Milford Zoning Board of Adjustment

Staff Review

Subject: Continuation of Case #2023-02-Variance Request, pursuant to Article VI, Section 6.01.3.B.7 to allow for the Retail Sale of Petroleum Products in the Town of Milford's Groundwater Protection Zone I, located in both the "C" (Commercial) Zoning District & Limited Commercial ("LC") Zoning District, Map 43 Lot 20-2

Re: Case # 2023-01,02,03 Rashid South Street Gas Station project MapLot 043-020-002

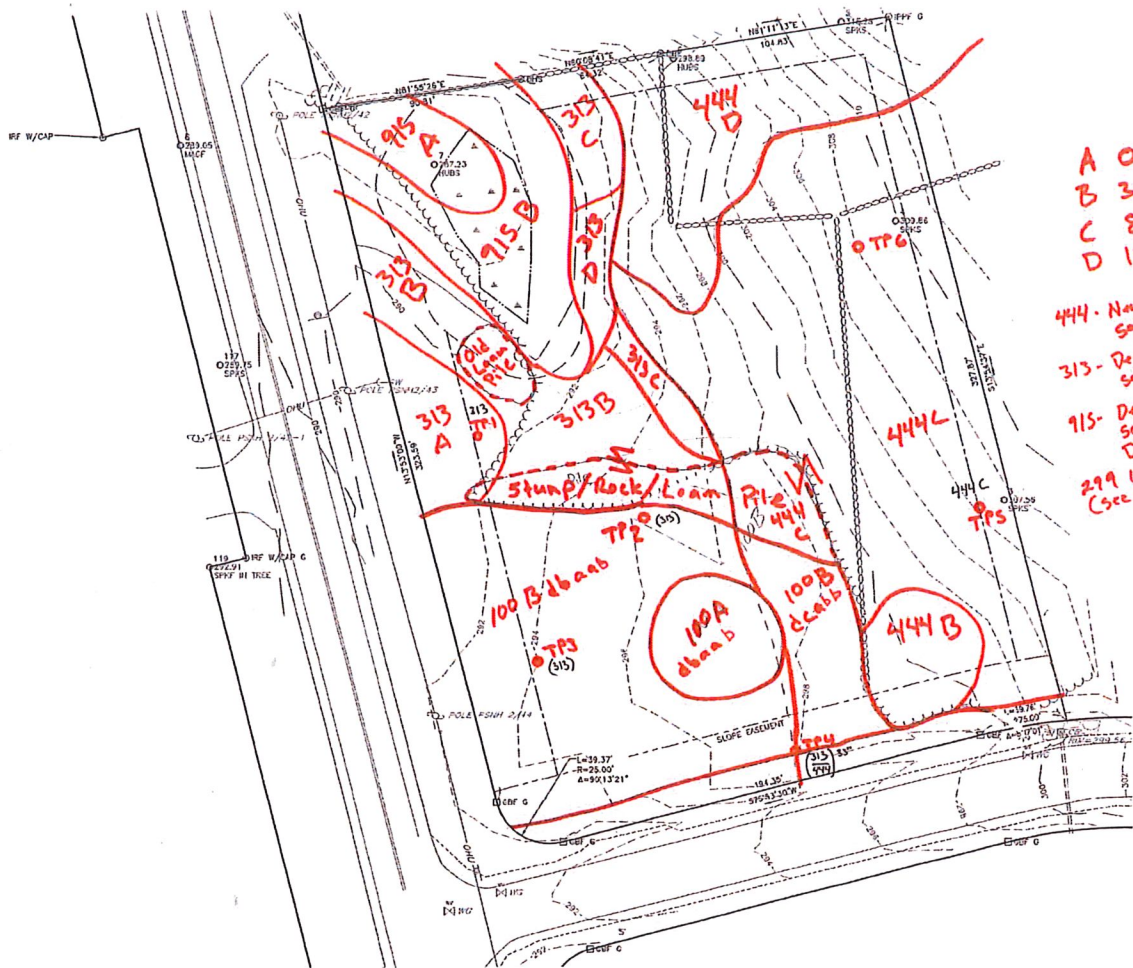
1. The Groundwater Protection Map. (See attachment).

- a. This map has generated discussion concerning its origin and scientific validity. This is the document which was accepted by the Town by way of the Planning Board in 2002. The 1985 Town Meeting approved (987Y/187N) to adopt an Aquifer Protection District ordinance. At the 2003 Town Meeting, residents approved (1991Y/431N) an updated ordinance titled The Groundwater Protection Overlay District which included this map.

- b. The soils mapped that are shown on this map are taken from the United States Geographical Survey soils mapping, more particularly in this case, the highly transmissive soils found in aquifers. The data used is found as a layer in the GIS mapping for Stratified Drift Aquifers on any State Natural Resource Mapper. These maps are tools used by land use boards to evaluate potential impacts to natural resources. An aquifer is a body of permeable rock which can contain or transmit water. The soil type shown on the gas station site plan is CaB (Canton B) soil. This soil is described, "Well drained. Runoff is

- c. The applicant refers to two private wells , one of which is now off-line, located in the Level I Protection Area identified on this map where the development would be sited. However, what has not been addressed is that the pumps and underground storage units would also be located less than 300 feet from a Level II Protection Area also identified on the map. A pollutant will move 2000 to 4000 square feet per day through this stratified drift soil type. Both the Level 1 and 2 areas are defined, by NH DES and USGS standards, in the Groundwater Protection Area Map legend.
